Comparison of Shielding Results

- Existing “Insert A” Addendum vs. Proposed Change

Figure 5-6. Expanded Elevation View of Insert Drain Line Region

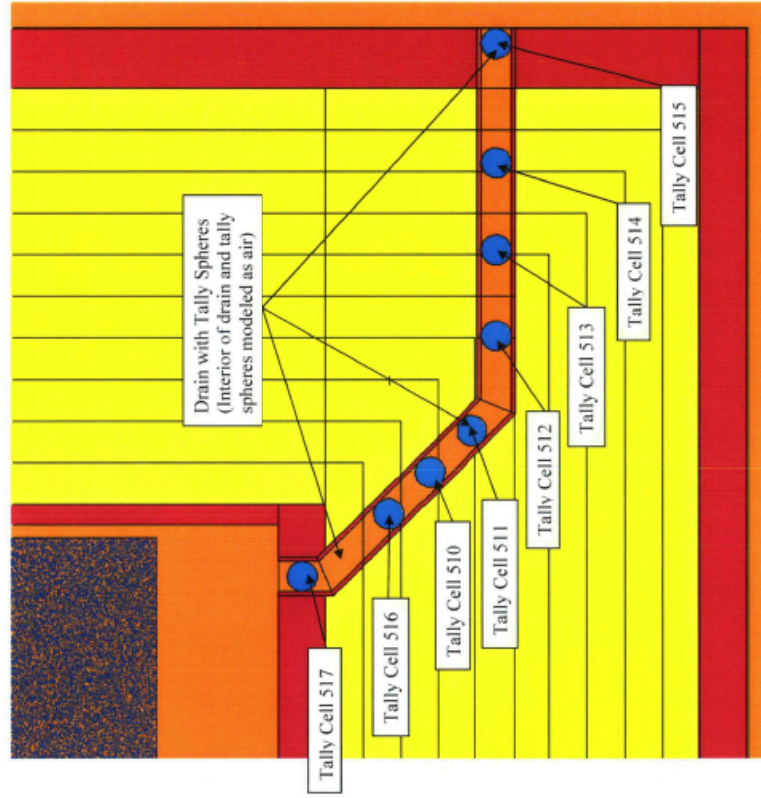
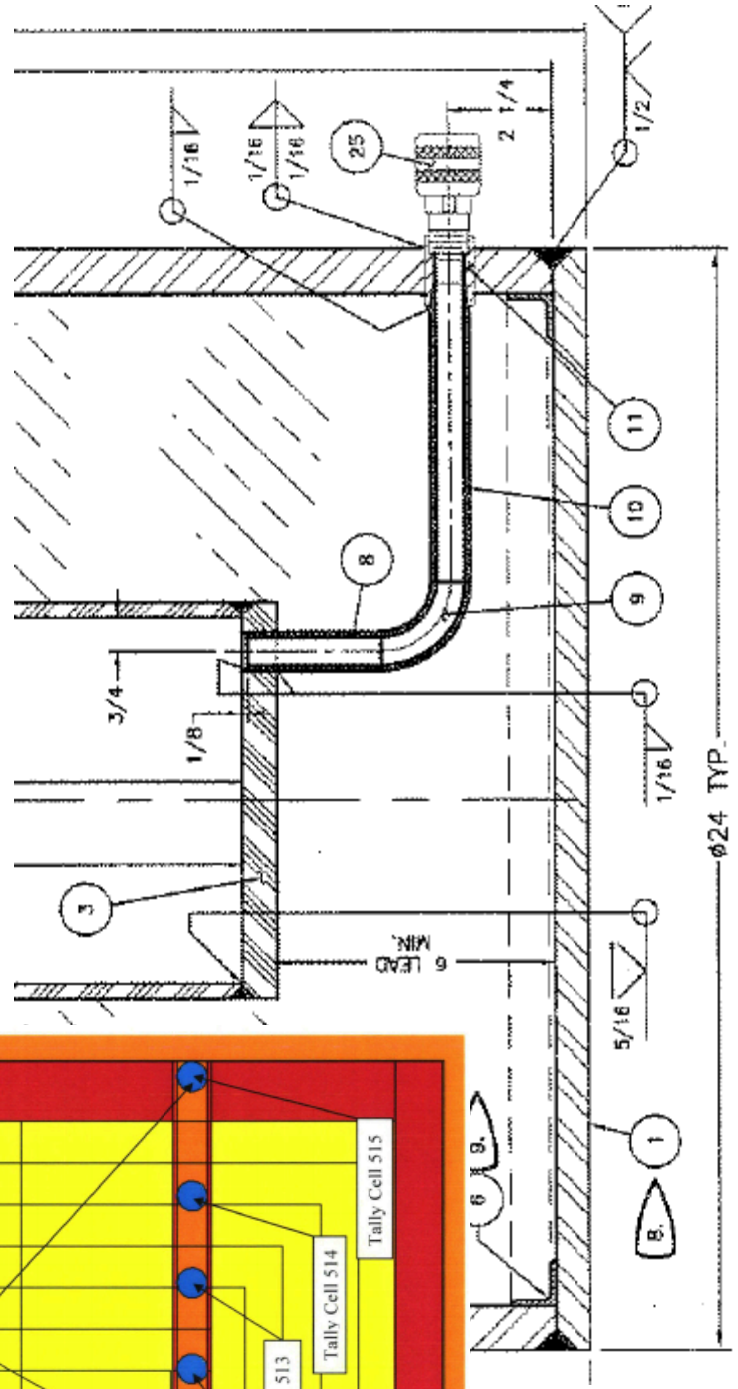
- 2.9 vs. 5.2: Now model annular gap at max value.
- 6.5 vs. 4.0: Now model package surface at IL vs. cask body.

- HACs: Now model 1m vs. contact, shored vs. not, volumetric vs. point source.
- Both old and new analyses conclude 3-4% of allowable limit.
